Safety Warnings for E-IO Safety System

Berghof Automation

Document History		
Version	Date	Comments
1.00	15.03.18	Initial-Version ERRATA Warning #1 added
1.01	24.01.2020	ERRATA Warning#2 and #3 added

Safety Warning #2, FSOE Watchdog

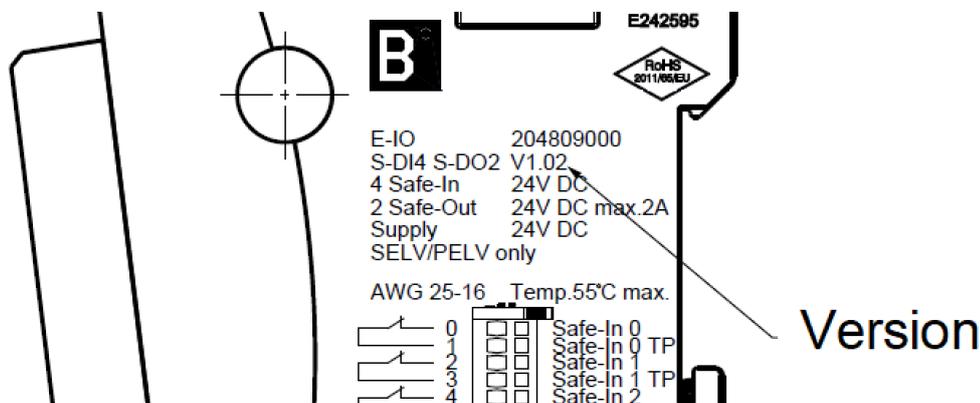
Title: FSoE Watchdogs can only be detected by Controller 2

In May 2017, the software was corrected for the so-called FSoE watchdog, in this change, only an incremental build was performed to create the release version, rather than a complete rebuild.

This left a test routine in the release, which sets the FSoE watchdog timer to 0 on controller 1. As a result, the watchdog can only be detected on controller 2, which then leads to non-congruent FSoE telegrams from controller 1 and 2 to the communication controller 3 in the following. Controller 2 reports FSOE watchdog and controller 1 reports no FSOE watchdog = incongruent telegrams. The communication controller 3, sets an error that prevents the transfer of FSoE telegrams from the FSoE master. This error can not be reset and the module remains in the safe state until the next power-up. In summary, it must be stated that the single-fault safety of the module is not guaranteed. A soft error in the timer component or the memory cell for the watchdog time in connection with the absence of valid FSOE telegrams potentially leads to an unsafe state. The status of the module is frozen - switched-on outputs remain switched on. The specified safety characteristics are not adhered to!

All modules are affected with the version 1.01, delivered from 15.6.2017.

All SDI4 SDO2 modules with version 1.01 must not be used. If you still have a module with this version, please contact Berhof Automation GmbH.
